RECEIVED
APR 19 2013
AND DEVELOPMENT SECTION

ENGINEER'S SEAL	Casas de Oro Townhomes 921 & 923 Montano Rd.	DRAWN BY WCW/J
		GRADING AND DRAINAGE PLAN	DATE 4-19-13
		 <i>Rio Grande</i> Engineering 1606 CENTRAL AVENUE SUITE 201 ALBUQUERQUE, NM 87106 (505) 872-0989	21319-LAYOUT-4-16-13
DAVID SOULE P.E. #14522			SHEET # —
			JOB # 21319

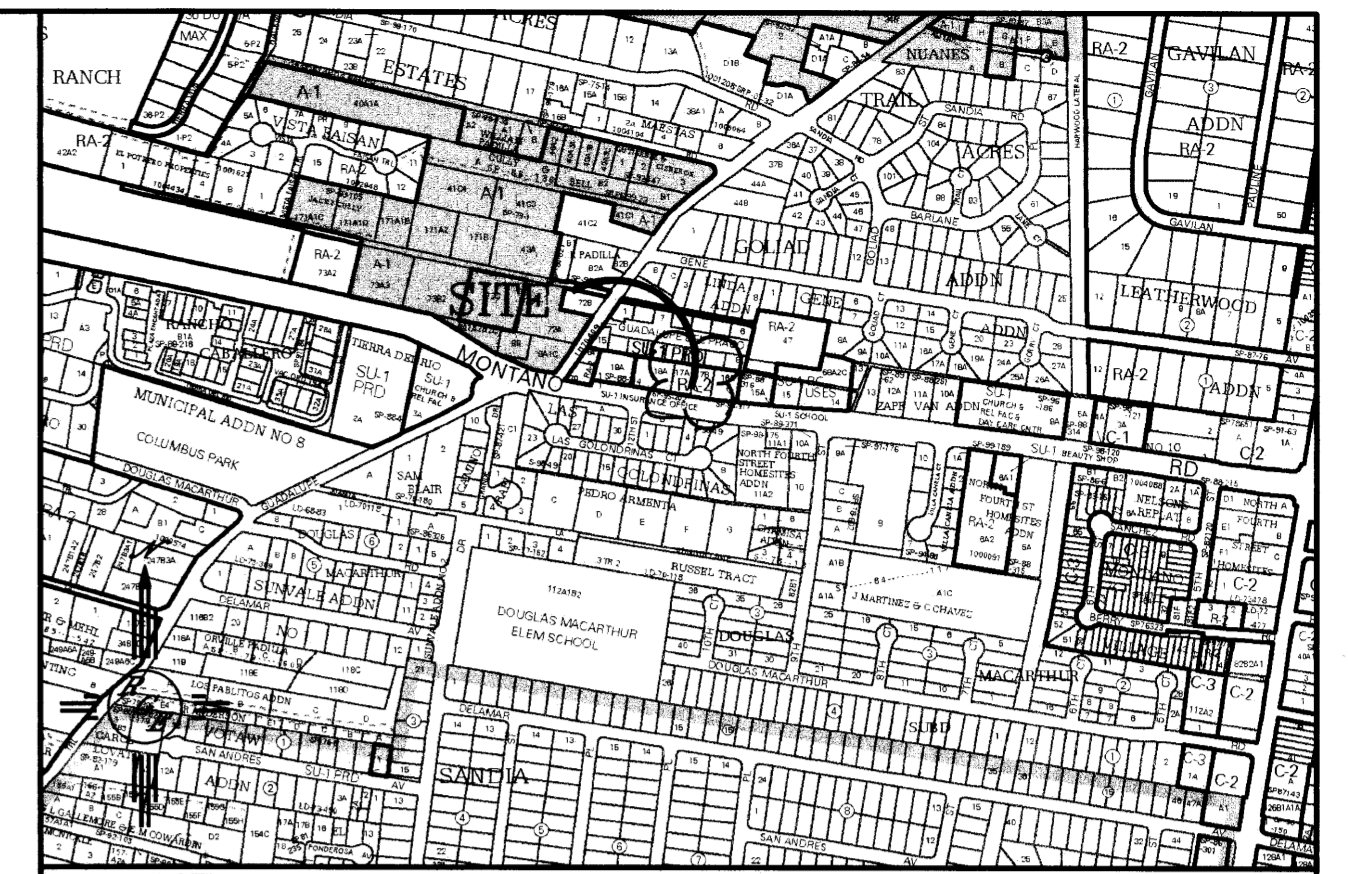
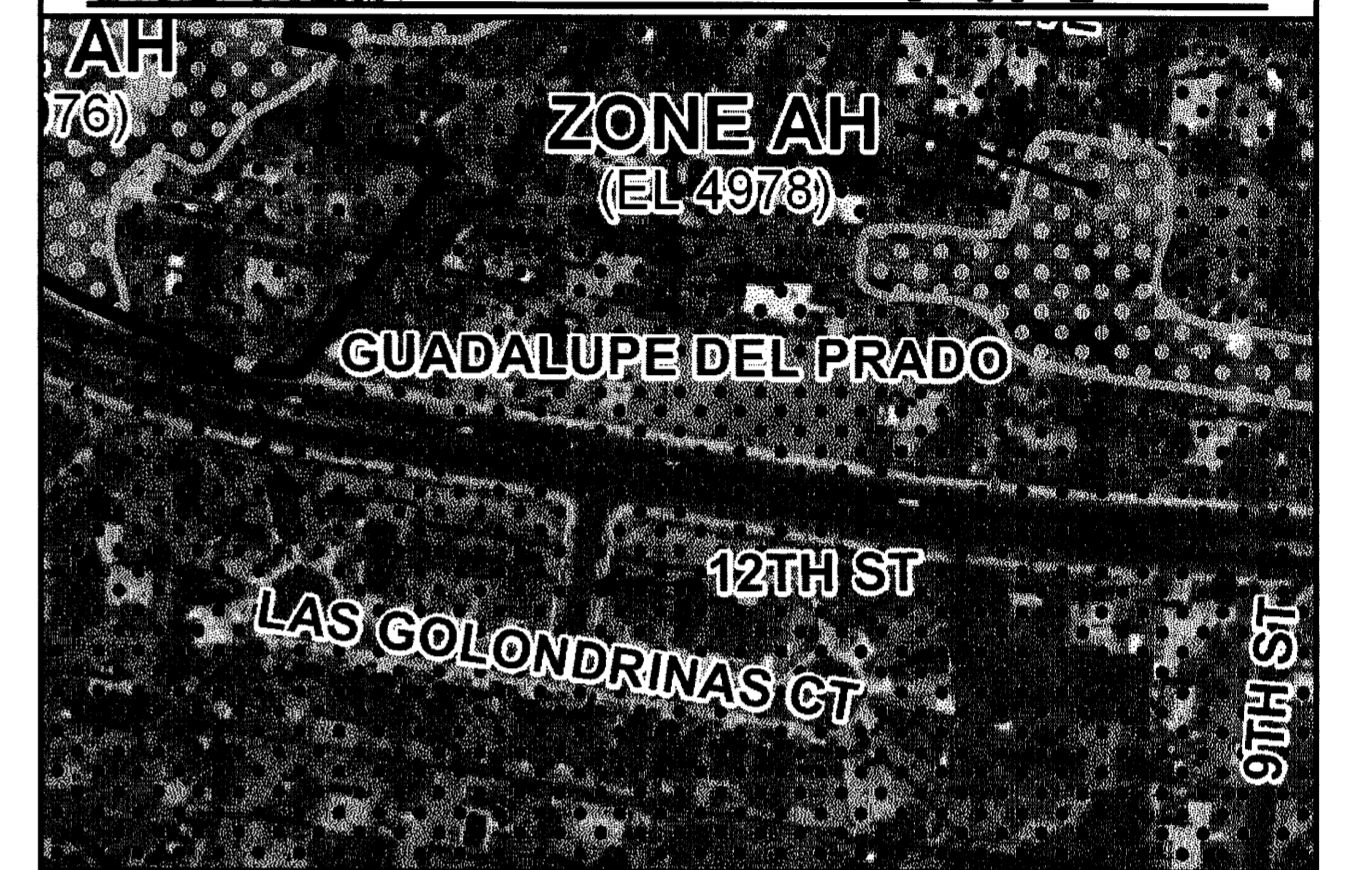
7.99
Dlact
4972.95

* Back of SW
elevation
* Back up against
object
lot to North

* 100 yr - 10 days
